HISTORIC AND DESIGN REVIEW COMMISSION

November 02, 2022

HDRC CASE NO: 2022-531
ADDRESS: 2031 W WOODLAWN AVE
LEGAL DESCRIPTION: NCB 1963 BLK 1 LOT 8
ZONING: R-6, H
CITY COUNCIL DIST.: 7
DISTRICT: Monticello Park Historic District
APPLICANT: Linda Sillik/KRE Group City Lic RBC-21-00645 Tonya Brown /CTC REAL
OWNER: ESTATE VENTURES LLC
TYPE OF WORK: Window replacement, repair and maintenance of porch and patio, painting
APPLICATION RECEIVED: October 06, 2022
60-DAY REVIEW: Not applicable due to City Council Emergency Orders
CASE MANAGER: Claudia Espinosa
REQUEST:

ReliaBilt Â 105 Series 31.5-in x 35.5-in x 2.625-in Jamb Vinyl New Construction White Single Hung Window Half Screen Included

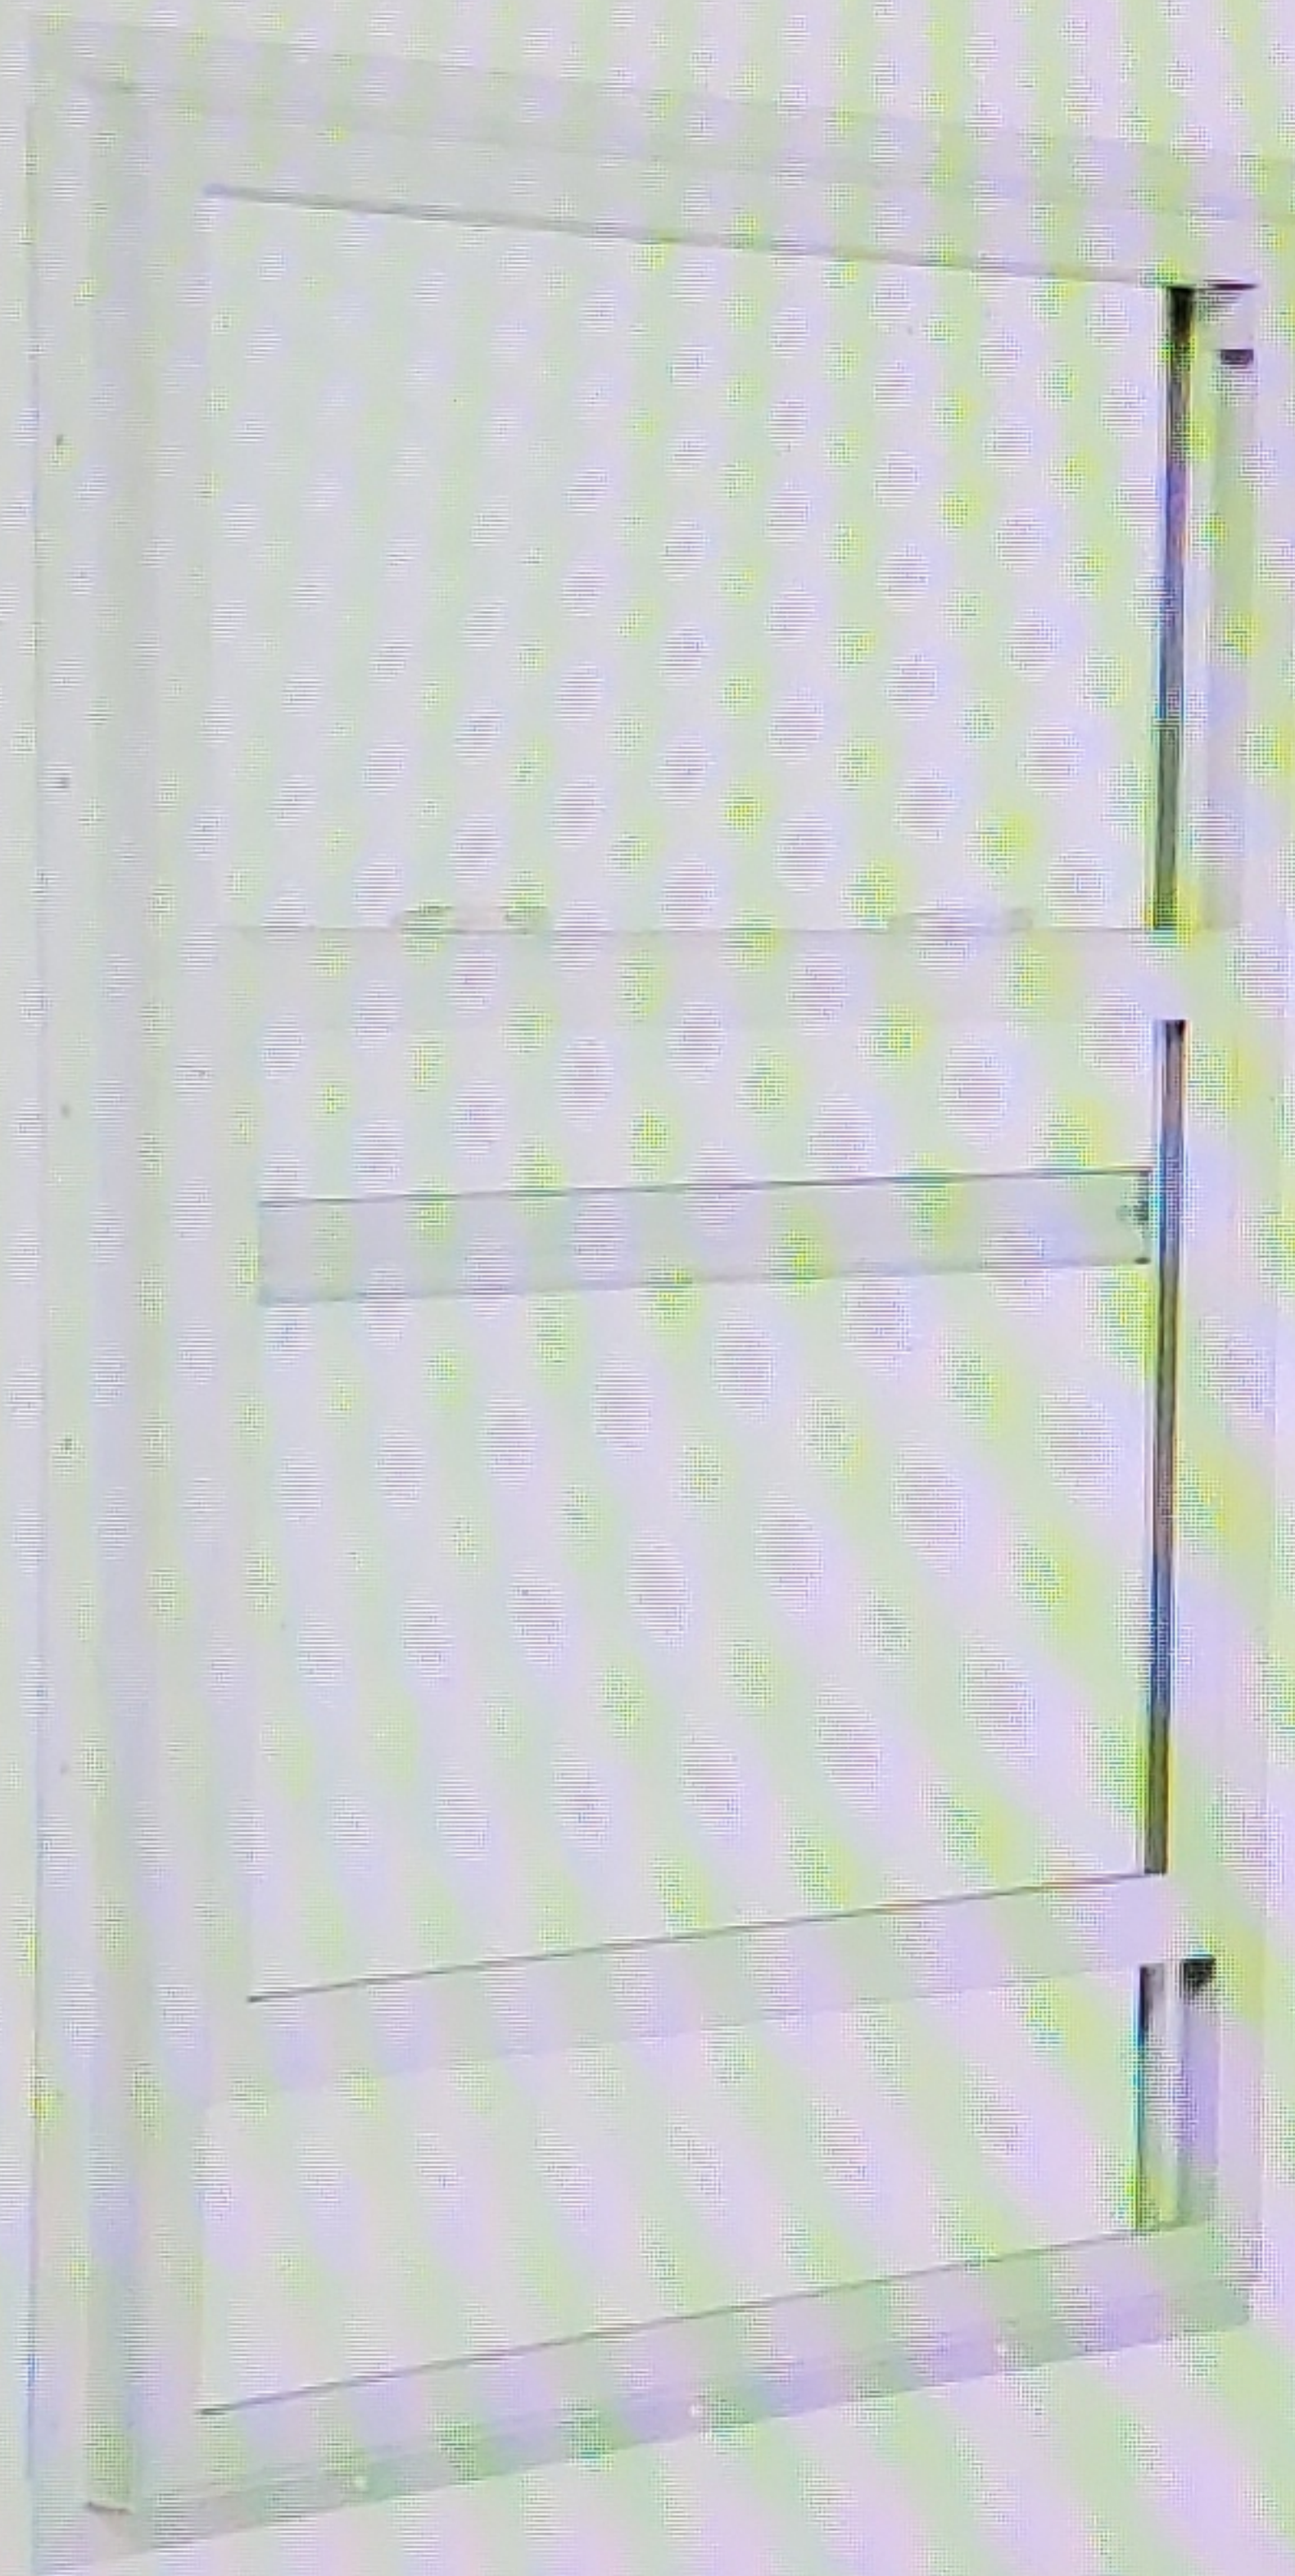
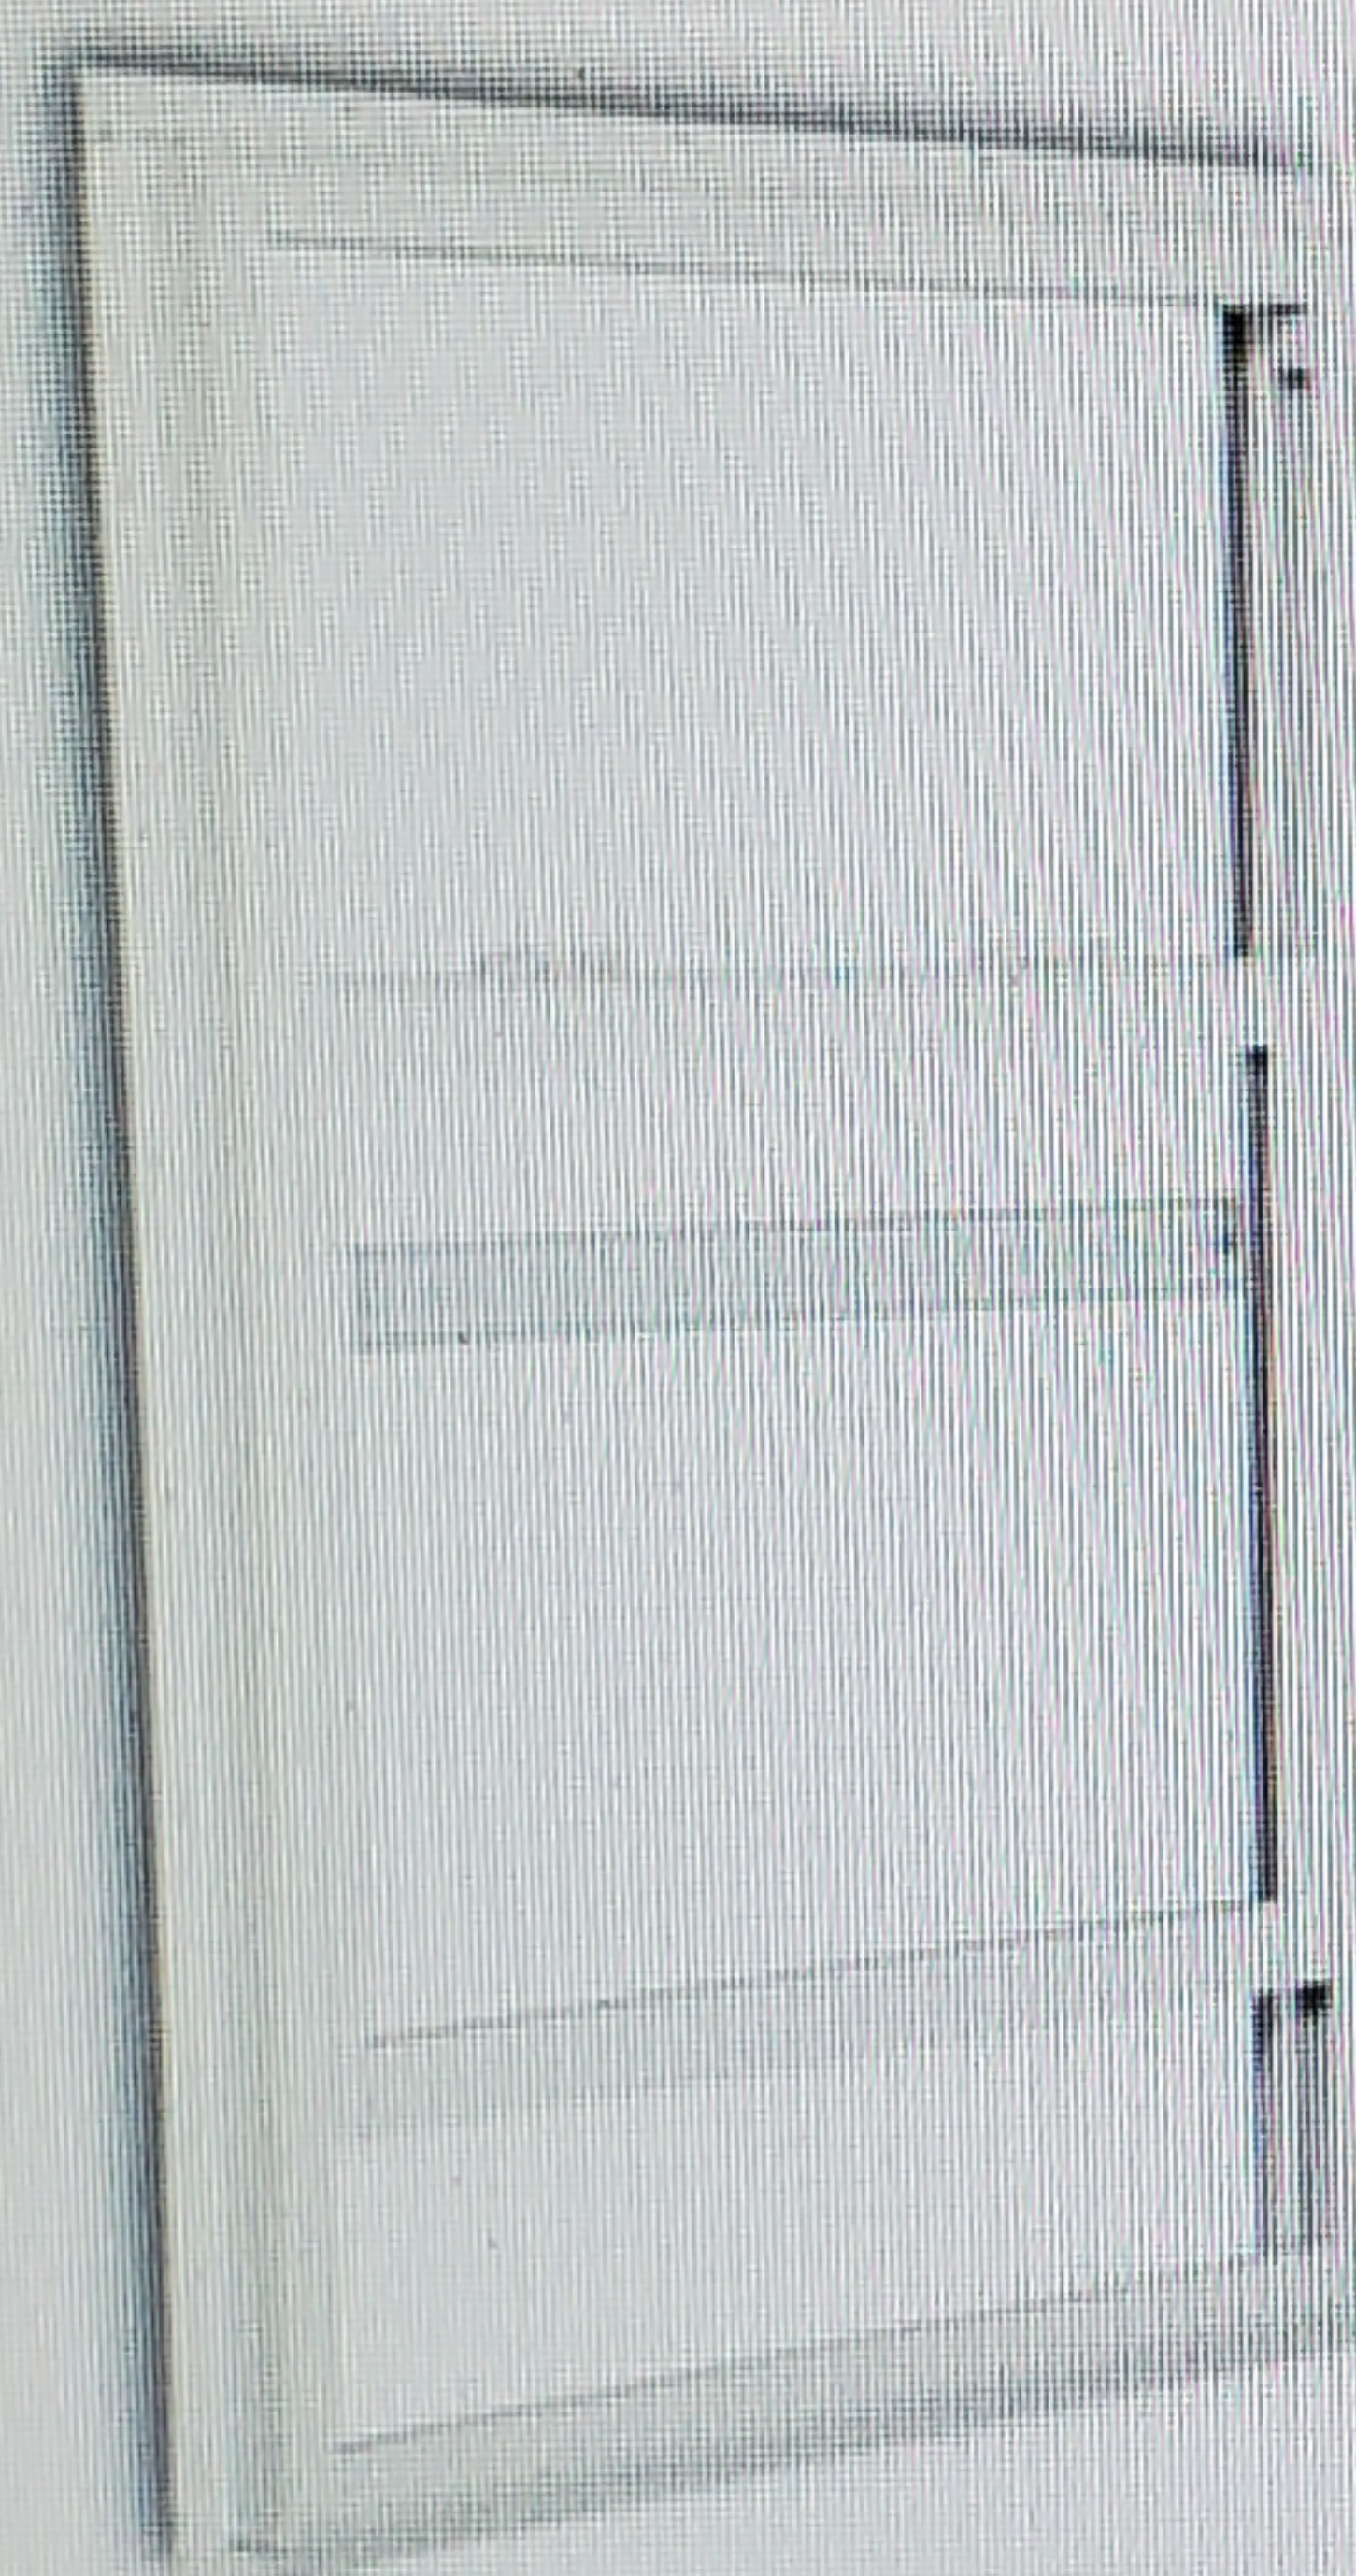
- e. **WINDOW REPLACEMENT** – The applicant has proposed to replace all existing, wood windows with vinyl, double-hung windows. The applicant has stated the original wood windows were disposed of due to their condition. Staff did not review the state of the windows prior to their removal and disposal. There is no record of the windows being beyond repair. Staff finds the proposed replacement windows are inconsistent with the Guidelines for replacement windows.

3. Staff does not recommend approval of the removal of twenty-five (25) wood windows and replacement with vinyl windows based on findings e.
 - a. Staff recommends that the applicant install the original wood windows that were removed.

- b. If the original wood windows are not available, staff recommends the applicant salvage wood windows that are appropriate to the home without significant changes to the existing fenestration patterns.

- c. Where salvaged windows are used, the windows must be fully wood windows that meet staff's standard window specifications and submit final window specifications to staff for review and approval prior to the issuance of a Certificate of Appropriateness. Wood windows should feature an inset of two (2) inches within facades and should feature profiles that are found historically within the immediate vicinity. Meeting rails must be no taller than 1.25" and stiles no wider than 2.25". White manufacturer's color is not allowed, and color selection must be presented to staff. There should be a minimum of two inches in depth between the front face of the window trim and the front face of the top window sash. This must be accomplished by recessing the window sufficiently within the opening or with the installation of additional window trim to add thickness. Window trim must feature traditional dimensions and architecturally appropriate sill detail. Window track components must be painted to match the window trim or concealed by a wood window screen set within the opening. Faux divided lites are not permitted.
